Number: FS-2014-02

Model: All Buses With Aeroquip FC-300
Coolant Hoses

Subject: Effects Of Coolant With O.A.T. On FC-300 Hoses

Figure 1: Engine Deaeration Hoses

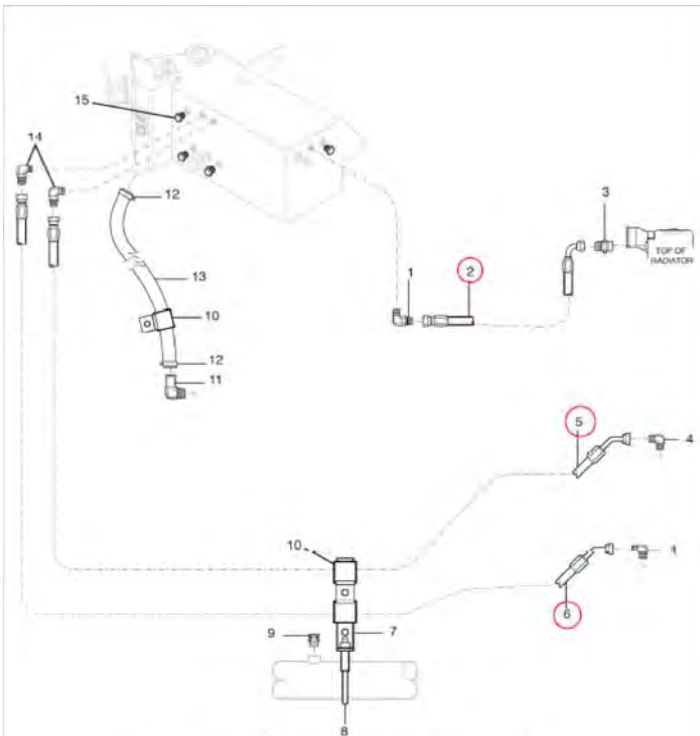
Eaton Aeroquip has recently determined that newer coolants containing OAT (organic acid technology), are not compatible with their FC300 hose material. Coolants containing OAT may lead to the breakdown of the inner liner of the FC300 hose possibly resulting in leaks, blockage of the hose or contamination of the cooling system.

The hoses which should be replaced are the deaeration hoses connecting to the surge tank and the coolant filter supply and return hoses. Refer to Section 1 in your parts manual to identify these hoses (examples are provided below for reference) and contact Gillig LLC parts department to determine appropriate replacement hoses. Silicone hoses are not affected by OAT and do not require replacement.

Although OAT coolant was not originally provided by Gillig LLC in your buses, if the coolant has been changed to one containing OAT it is recommended that you replace all FC300 coolant hoses with FC186 hoses which have a Teflon inner tube construction and is approved by Eaton for all Ethylene Glycol, Propylene Glycol and Glycerin coolants including those with OAT.
